# RENESAS TECHNICAL UPDATE

Product Category	MPU/MCU		Document No.	TN-RZ*-A0087A/E	Rev.	1.00
Title	RZ/G2M V1.3 Additional Explanation for Ethernet AVB-IF		Information Category	Technical Notification		
Applicable Product	RZ/G Series, 2nd Generation RZ/G2M V1.3	Lot No.	Reference Document	RZ/G Series, 2nd Generation User's Manual: Hardware Rev.1.10 (R01UH0808EJ0110)		
		All lots

Section 46. EthernetAVB-IF

Figure 46.91 Data Transfer Function Stop Flow2 after Read Access Error

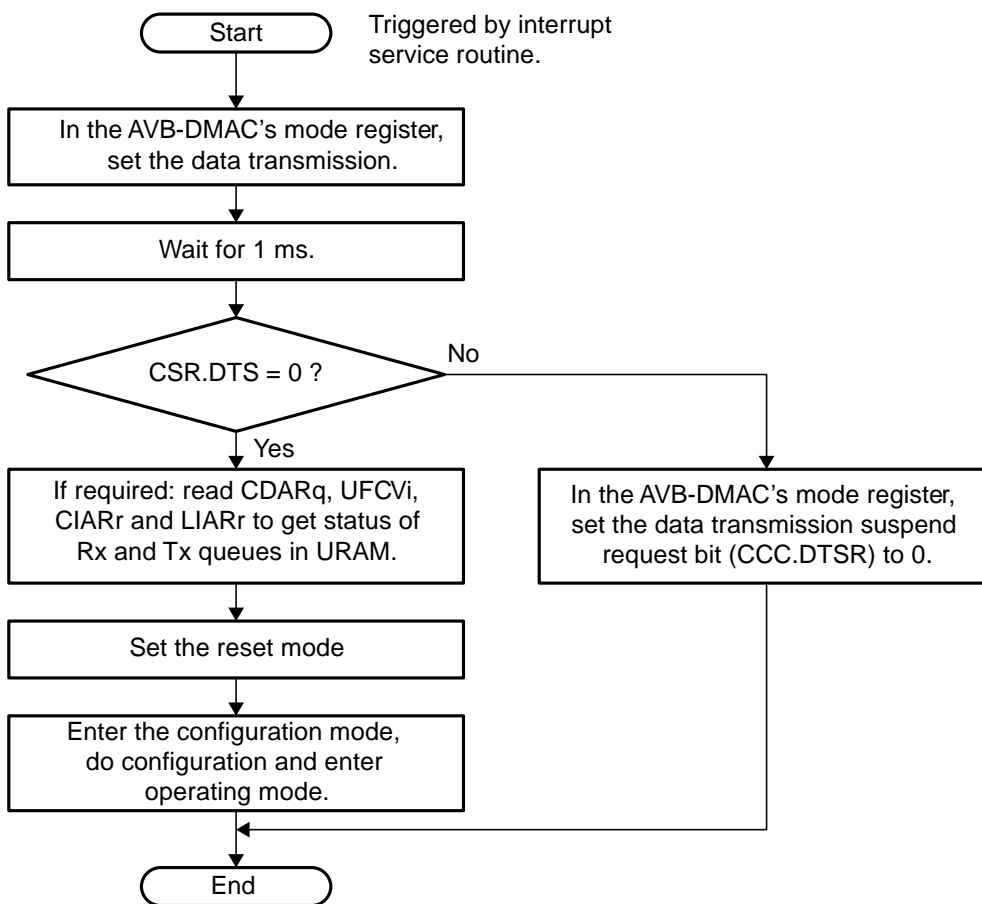
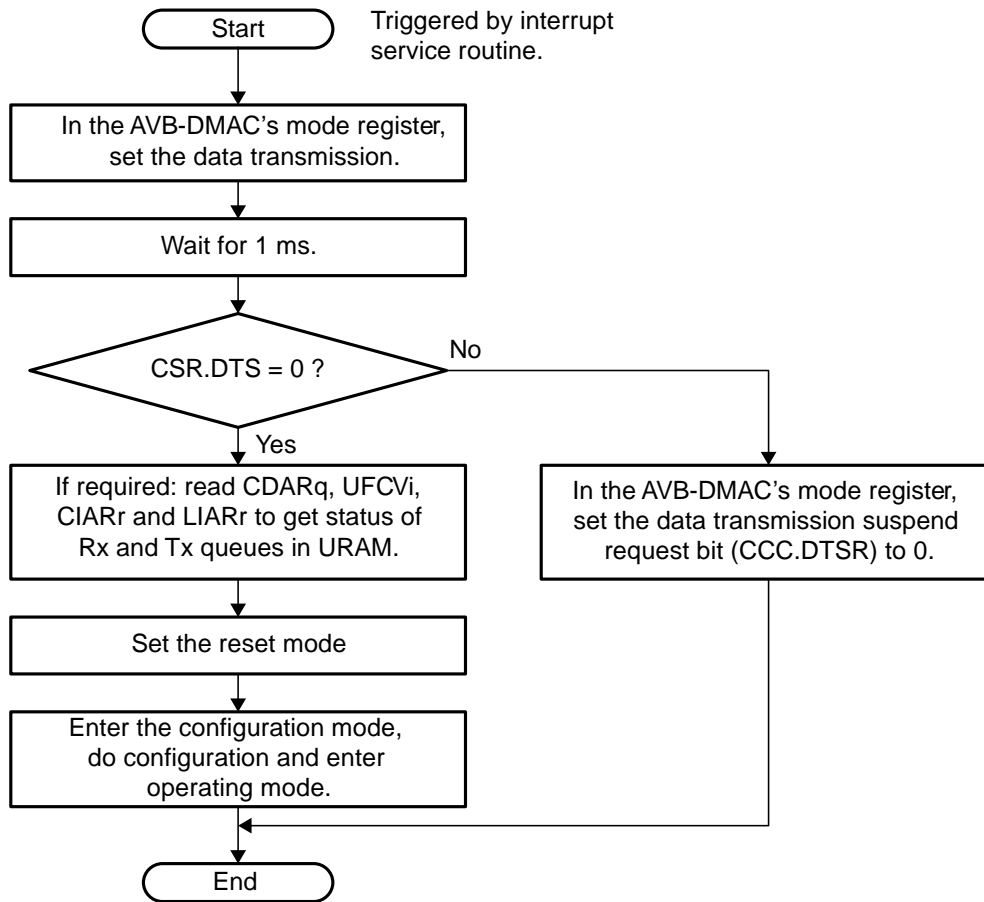
- Section 46. EthernetAVB-IF, Page 46-334, 46.4.4 Register Description, (d) Display Plane Register Configuration, Alpha blending related registers are added.

**46.4.4 Ethernet AVB RGMII Clock Delay Mode is generating low analog delay for RZ/G2M V1.3**

When using LSI's transmit internal delay mode in RGMII transmission, an error may be detected by the opposite device. Background is that not sufficient analog delay is generated by the Internal delay function. Please note that AC specification of RZ/G2M V1.3 is different for other RZ/G second generation products.
